## REVISED RESPONSE TO REQUEST FOR ADDITIONAL INFORMATION

### APR1400 Design Certification

Docket No. 52-046

**RAI No.:** 252-8299  
**SRP Section:** 03.07.02 – Seismic System Analysis  
**Application Section:** 3.7.2  
**Date of RAI Issue:** 10/19/2015

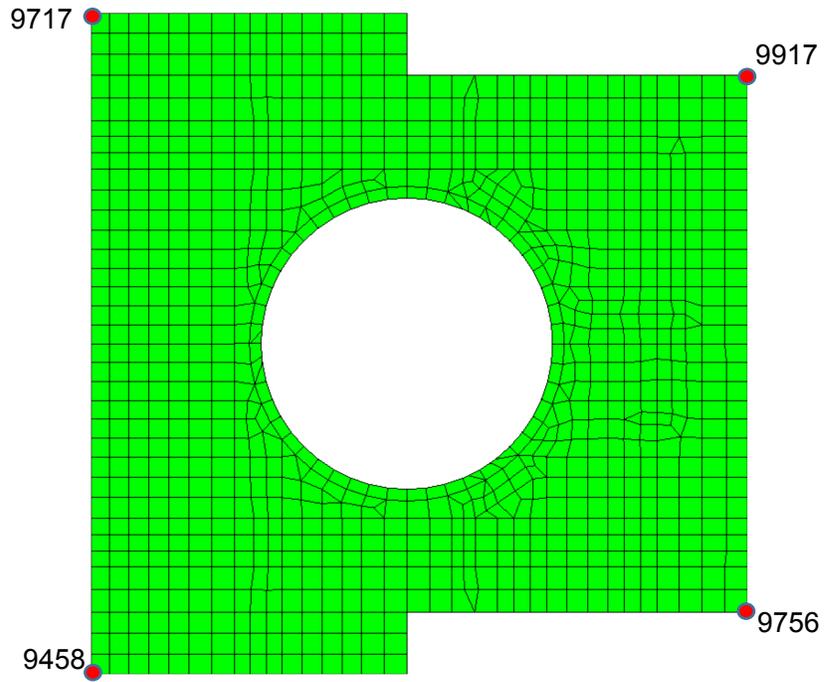
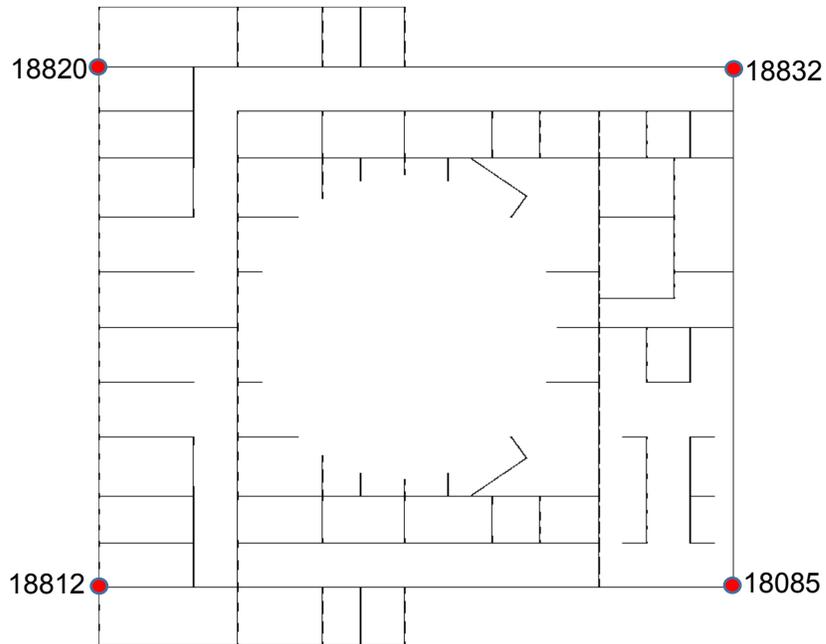
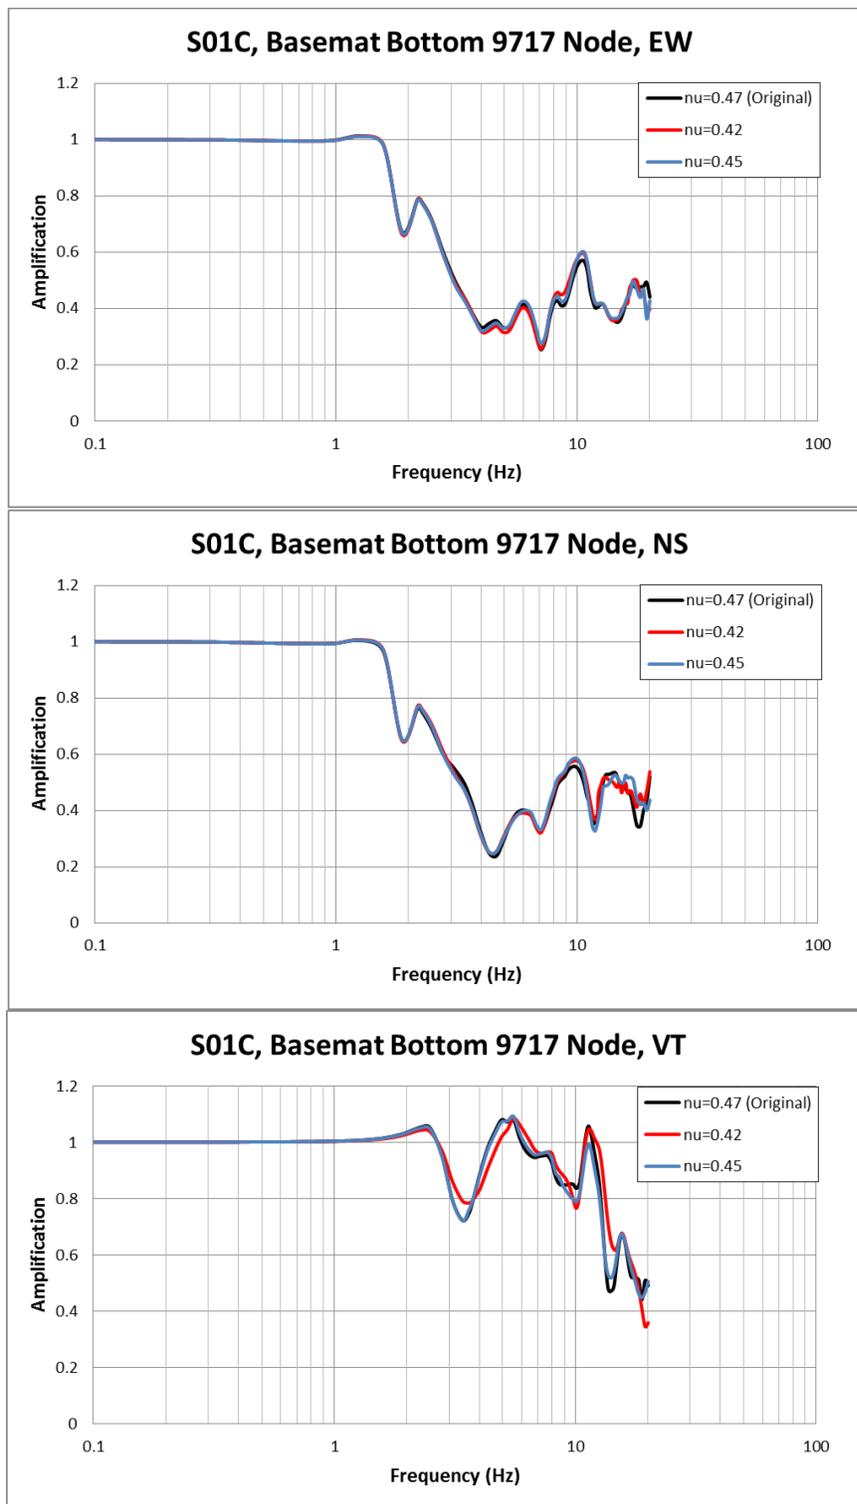
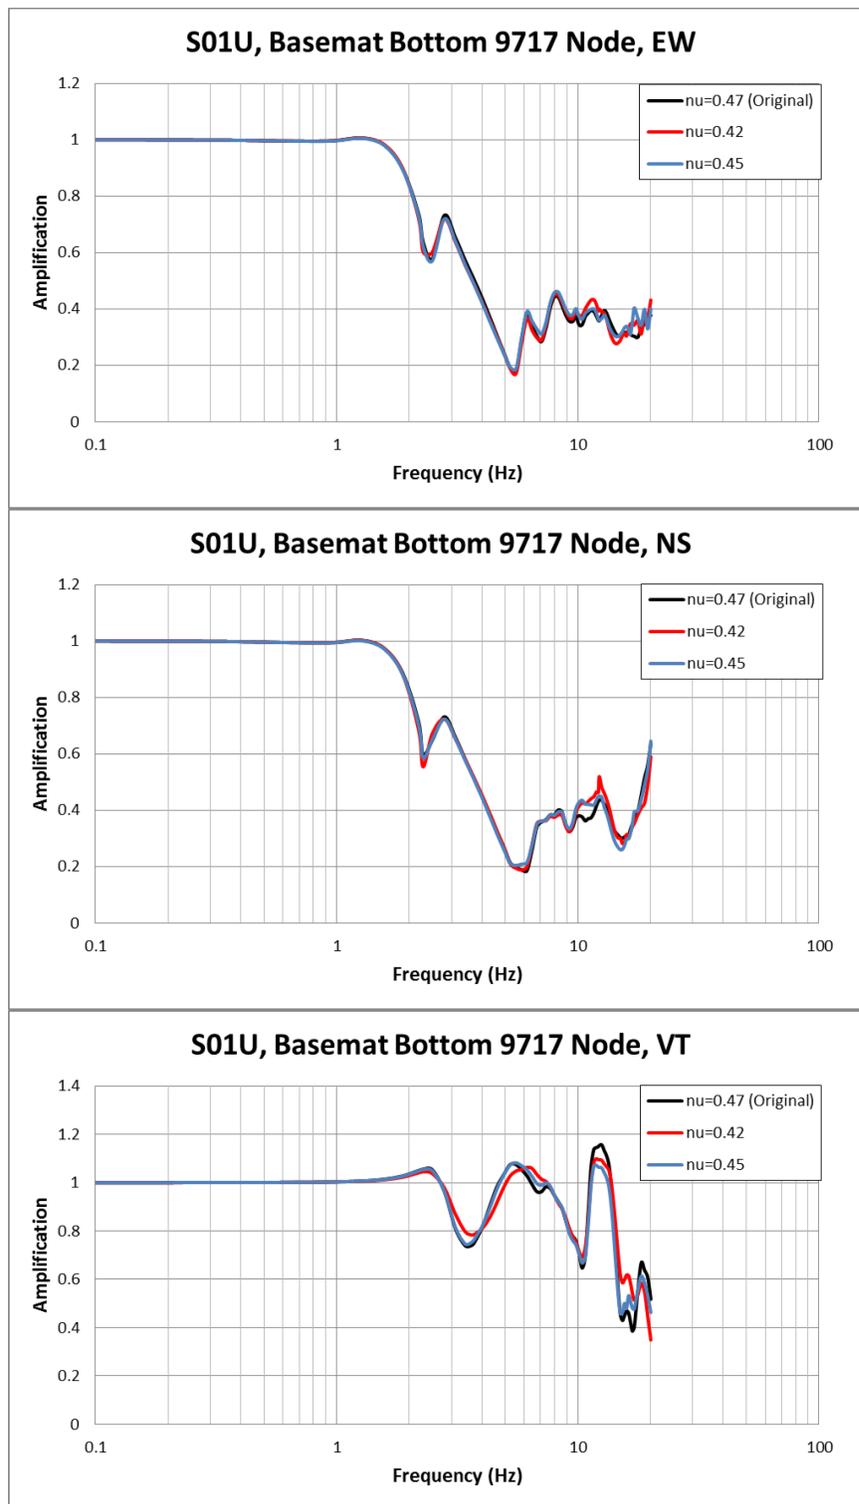
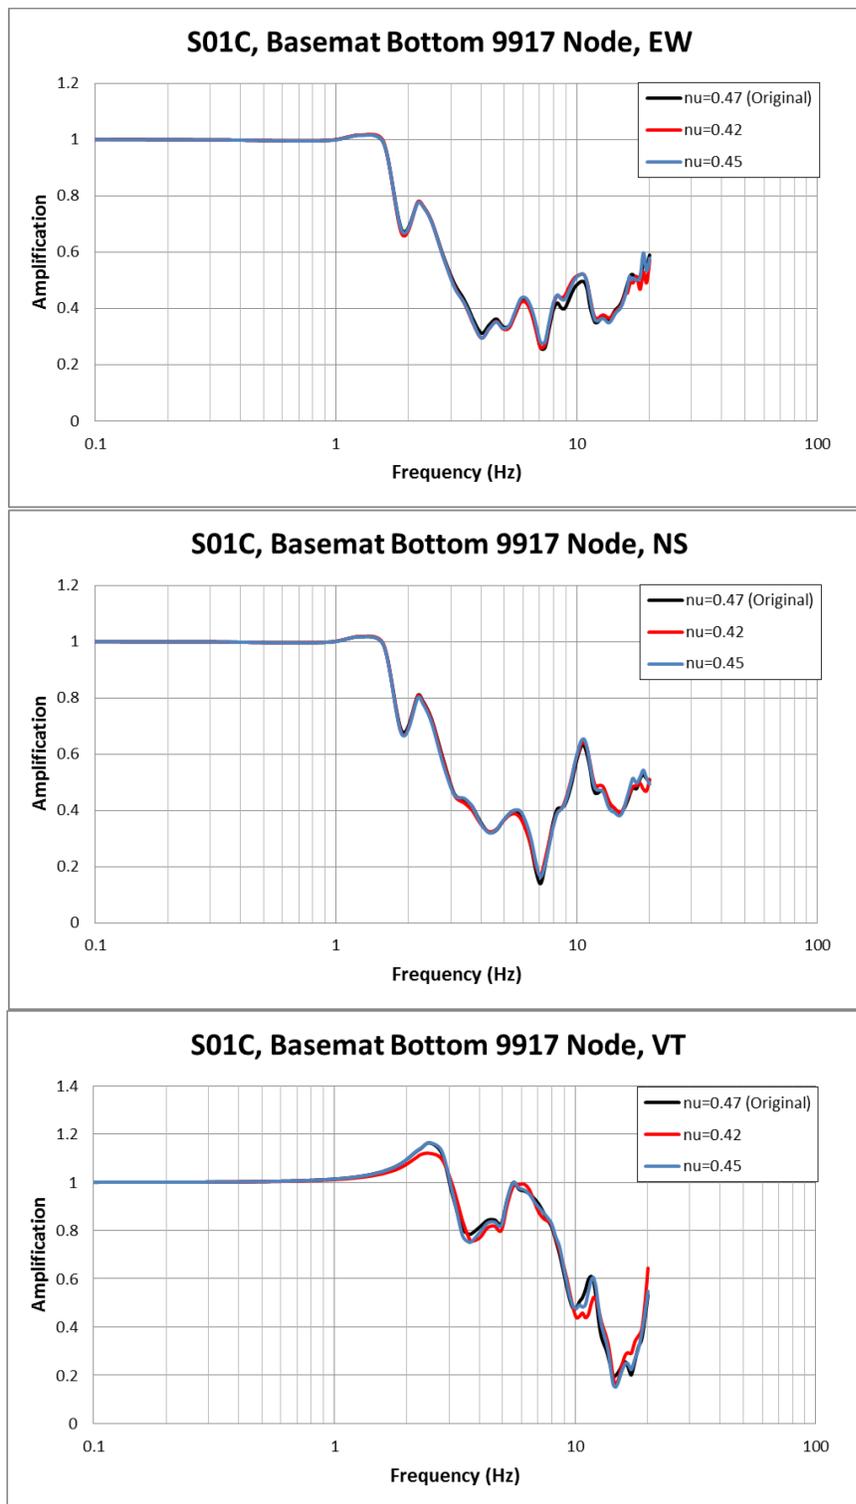
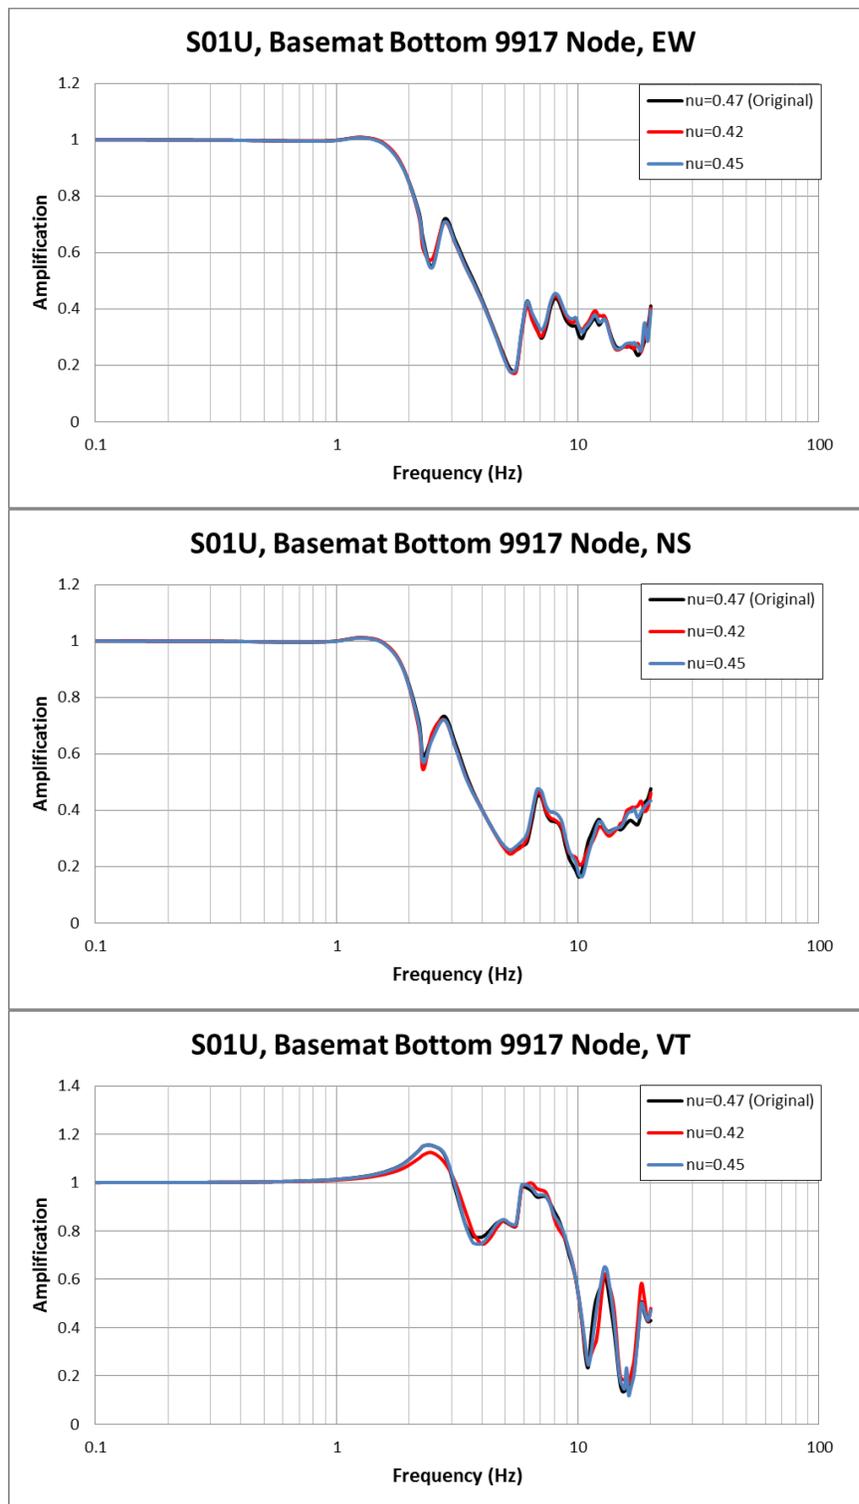
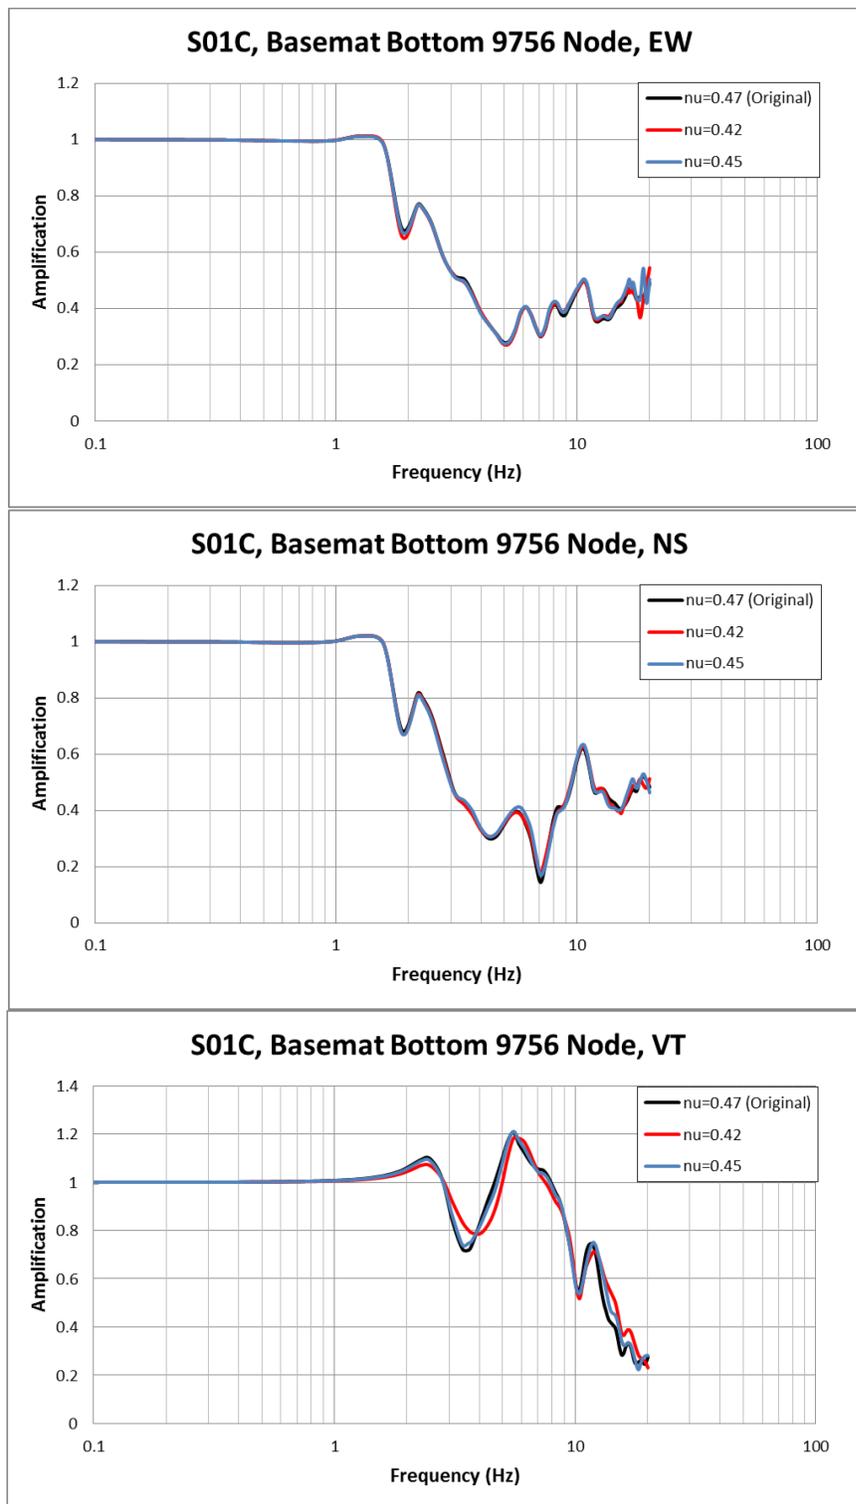
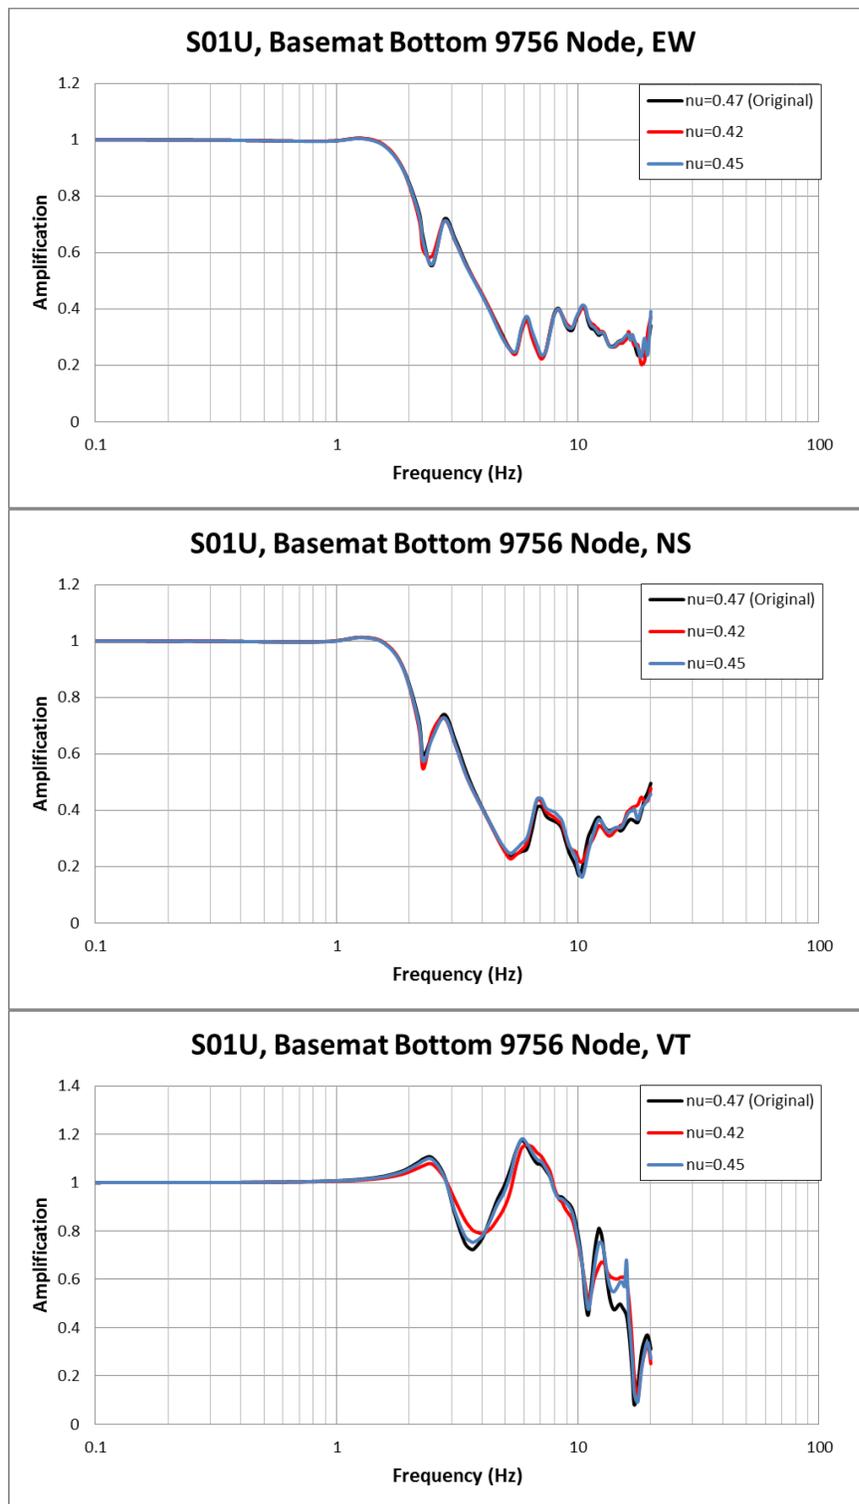
e) Poisson's Ratio Used in SSI Analyses

DCD Tables 3.7A-1 and 3.7A-2 show Poisson's ratios in the S1 and S2 soil profiles used for SSI analysis as great as 0.47 and 0.48 respectively. Based on staff experience, use of Poisson's ratio approaching these values may result in numerical instability of the SSI analysis results. Therefore, to assist the staff in evaluating the adequacy of the SSI analysis results based on the aforementioned soil profiles, the staff request the applicant to provide a demonstration (e.g. sensitivity study) that the assumed Poisson's ratio values do not produce numerical instabilities in the SSI results based on these profiles.

Using the modified soil profiles of S1 and S2, SSI analyses of NI models of both cracked and uncracked concrete stiffness cases are re-performed. Then, the transfer function results at NI basemat bottom and plant grade elevations obtained from the original SSI analyses and the re-performed SSI analyses in the sensitivity study are compared to judge the existence of numerical instabilities in the original SSI results. The locations of the selected nodes at basemat bottom and plant grade elevations using in the comparisons are provided in Figures 18 and 19. The comparisons of transfer function results for S1 and S2 soil profile cases are presented in Figures 20 through 51.

As shown in the comparisons of transfer functions presented in these figures, the transfer functions obtained from the original SSI analyses are quite similar and comparable to the transfer functions obtained from the sensitivity study re-performed SSI analyses. In addition, no abrupt changes or spurious peaks, which tend to indicate existence of

numerical sensitivities in the SASSI solutions, appear in the computed transfer functions of the original SSI analyses that have the maximum dynamic Poisson's ratio values of 0.47 and 0.48 as well as in the re-computed transfer functions that have the maximum dynamic Poisson's ratio values limited to 0.42 and 0.45. These results demonstrate that there is no numerical instabilities in the original SSI analysis results of the S1 and S2 soil profile cases.
